RE: Skagway Ore Peninsula Redevelopment Descoping Pricing

Please find attached Pacific Pile & Marine's (PPM) proposal for the Skagway Ore Peninsula Redevelopment De-Scoping Pricing based on drawings received 07/05/2023 and discussions thereafter.

ORE PENINSULA REDEVELOPMENT
SKAGWAY, ALASKA

1 CONNECTION TO EXISTING FUEL LINES
U6.30 SCALE: NTS

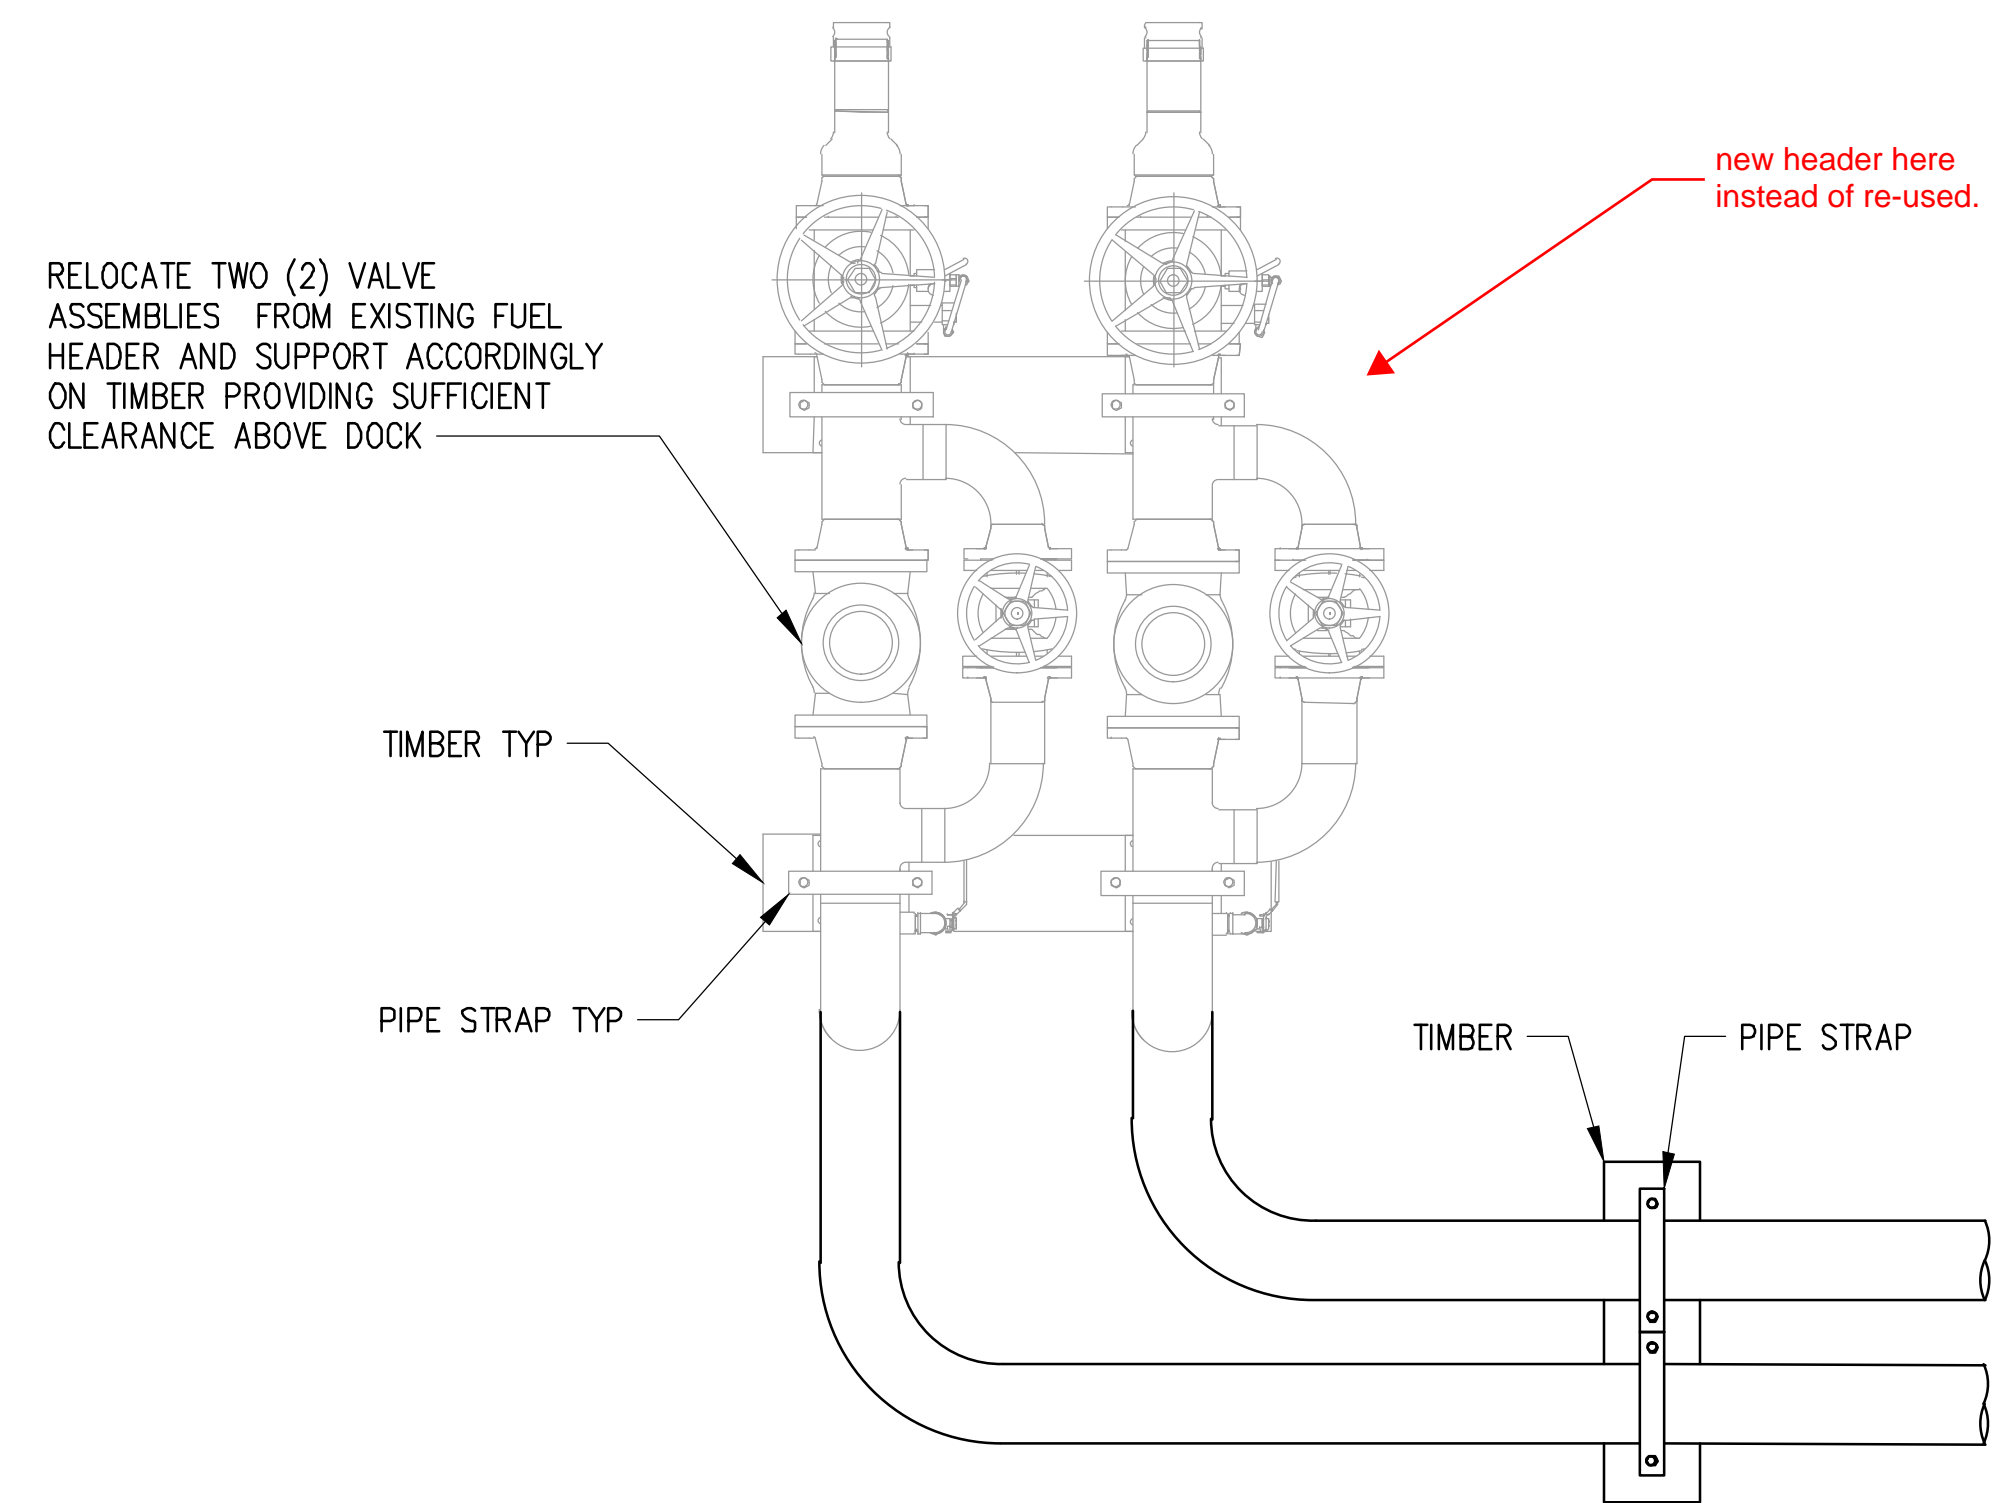
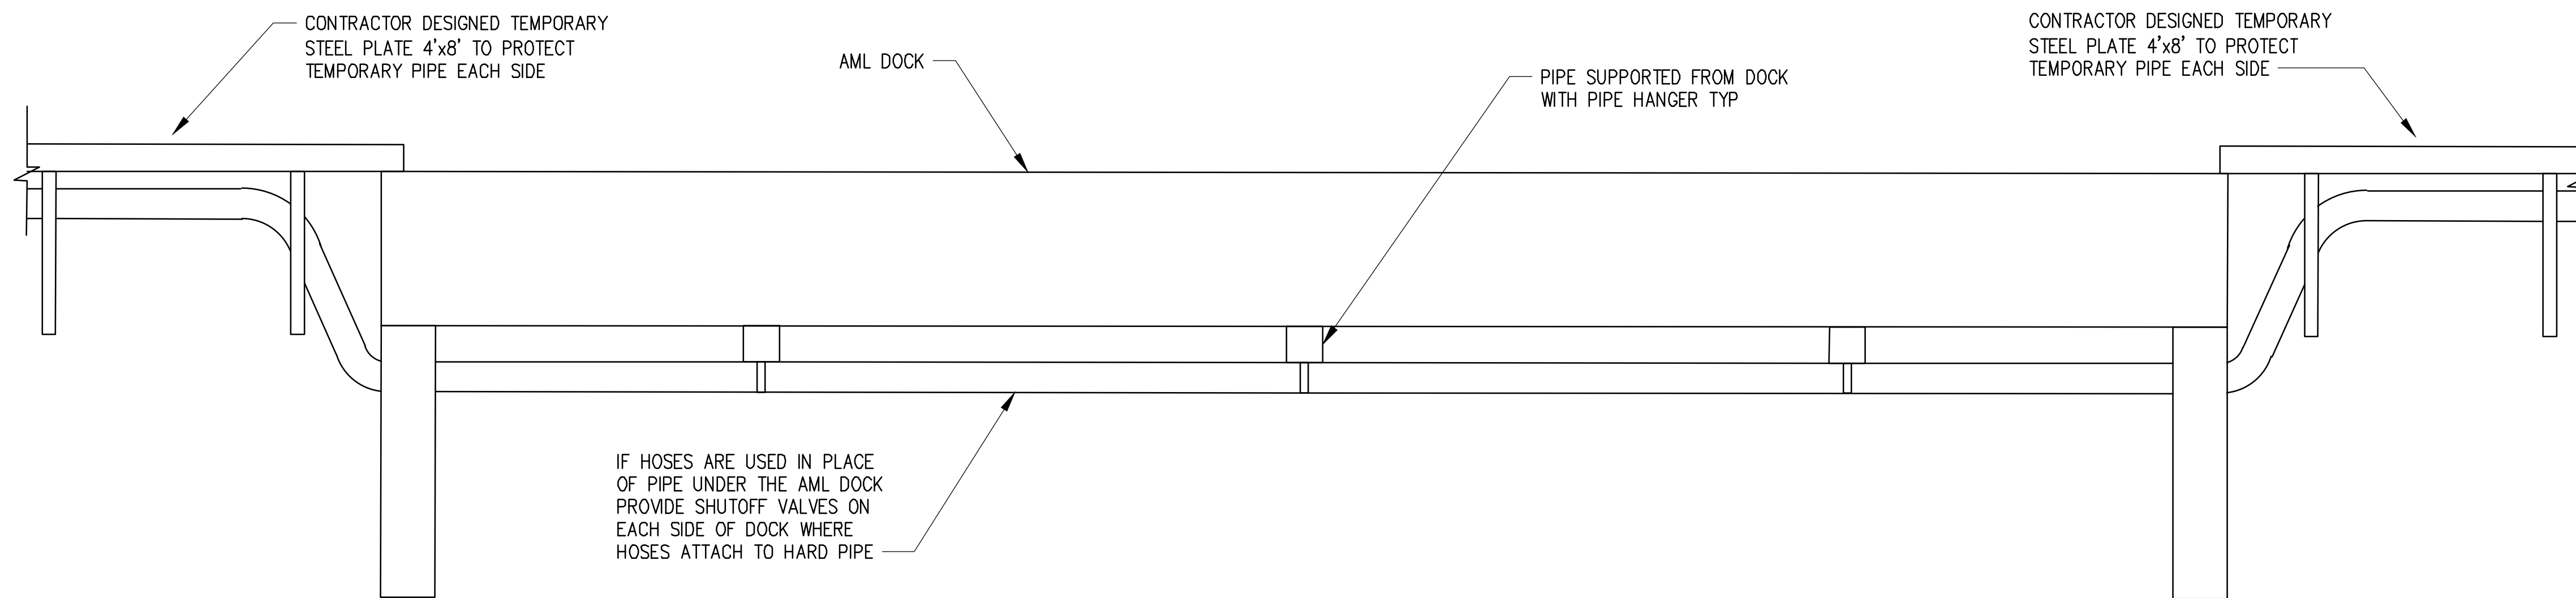
TEMP FUEL LINE RE-SCOPE 7.7.2023
